SERVICE BULLETIN

APPLICABILITY: 2020MY Legacy and Outback Models **NUMBER:** 15-261-20R
SUBJECT: Reprogramming File Availability for Optimization of Gen 4 Denso CP1 Infotainment Systems **DATE:** 03/10/20
REVISED: 08/13/20

The following information announces reprogramming file availability and provides a software update installation procedure to optimize the new Gen 4 Denso CP1 Audio and Navigation head units utilized in the models listed above. As in previous models, the procedure will involve either downloading the software update files from Subarunet or using those sent directly from Nuspire to the SDS Notebook and transferring them onto a USB flash drive for head unit installation.

Conditions Addressed By Update #1:

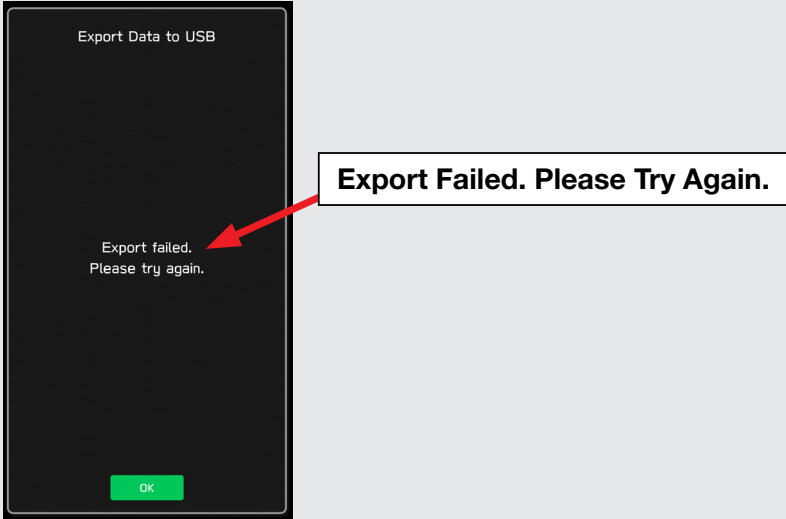
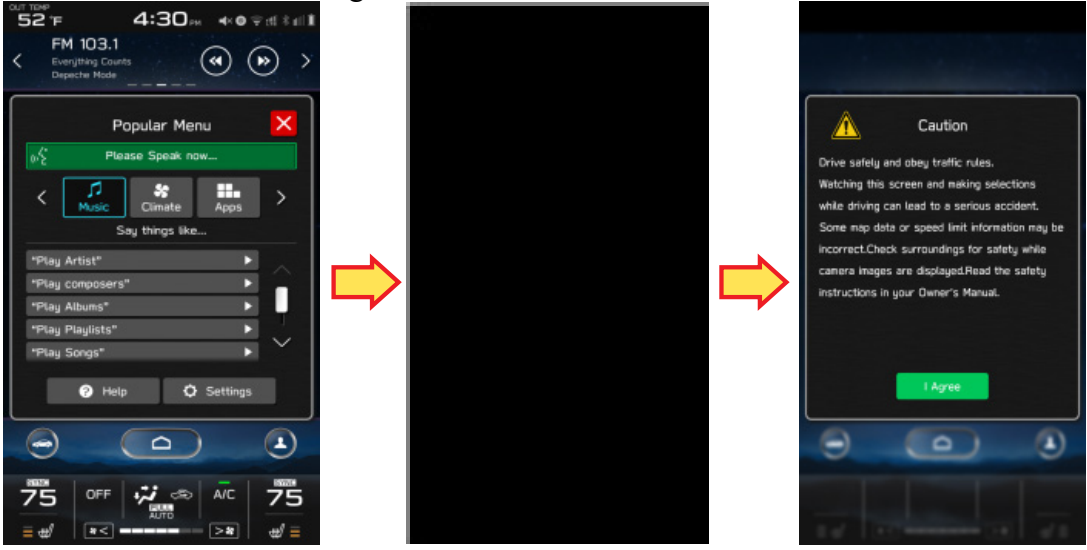
Symptom #	Description of Symptom:
1	<p>The CP1 display and/or center Combination Meter display freezes. No response from touch screen or voice guidance. After switching the ignition off and opening the driver’s door, the system does not recover**.</p>  <p>**NOTE: After switching the ignition off and leaving the driver’s door open more than 70 seconds, the system <i>may</i> recover after switching the ignition back on.</p>
2	<p>Delayed response of rear view camera guide lines. When the rear view camera is activated and the steering wheel is turned, there is a delay before the steering-responsive guide lines respond to the steering wheel input.</p> 
3	<p>Fuel consumption display has unnecessary ‘Φ’ mark when changing mileage unit to Km.</p>

Symptoms Addressed By Update #2:

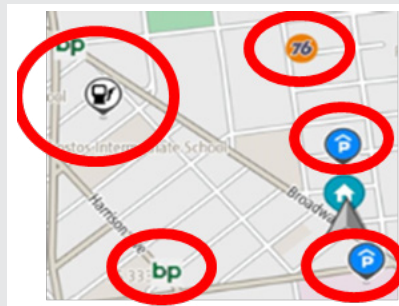
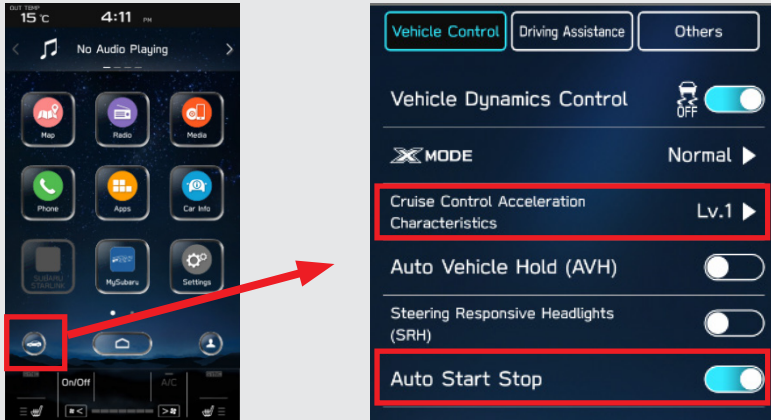
Symptom #	Description of Symptom:
9	In a case where the system was shut down while the Navigation map screen was being displayed, the display goes blank (black screen) soon after the Disclaimer screen is displayed after restarting.
10	CID reboots repeatedly after setting a destination using the Navigation system.
11	CID reboots while using the Pandora application via CarPlay.
12	Bluetooth connection cannot be reestablished when using certain smart phones. When using Android Auto on certain smartphones, a Bluetooth connection cannot be reestablished automatically once it has been disconnected.
13	CarPlay connection cannot be established. When connecting an iPhone via USB, "CarPlay Unavailable" is displayed and CarPlay does work.
14	The HOME screen goes blank. When the screen is switched from Camera mode to HOME, no icons are displayed as shown below.

List of New Functions and Enhancements Included in Update #2:

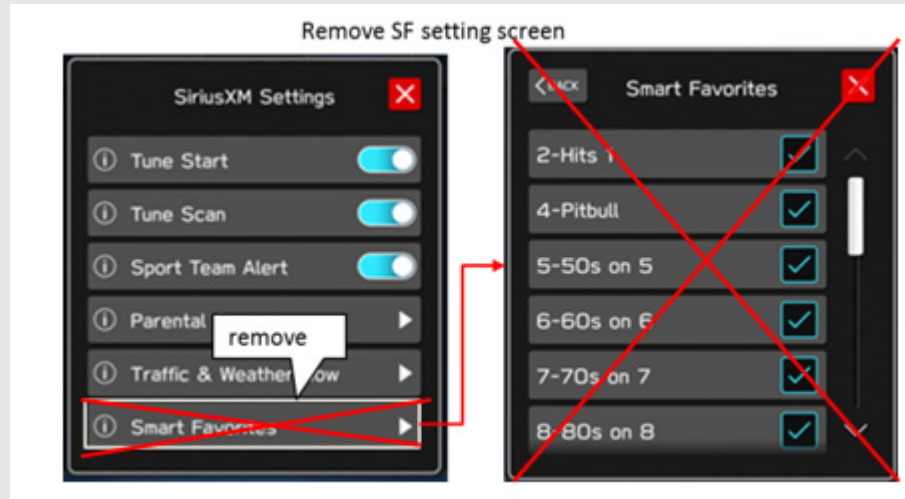
Number	New Functions and Improvements:
9	<p>CarPlay screen is now expanded from half size (horizontal) to full screen (vertical).</p> 
10	<p>When using CarPlay or Android Auto, a “CarPlay” or “Android Auto” tab will now appear on the Media tab bar. By selecting this tab, music data and metadata can be browsed.</p> 
11	<p>When using route guidance with CarPlay navigation, <Turn by Turn> descriptions will be displayed both in the Information bar of CID and in the MID located in the center of the combination meter.</p>
12	<p>By touching the new CarPlay button located at the top of the CID, the CarPlay menu can be accessed easily.</p> 
13	<p>In a case where the system is shut down while is CarPlay connected, the system automatically resumes the connection at the next start up.</p>
14	<p><Siri> Voice Recognition function is ready to use faster than with previous version.</p>
15	<p>Gracenote Media Database updated to November 2019.</p>
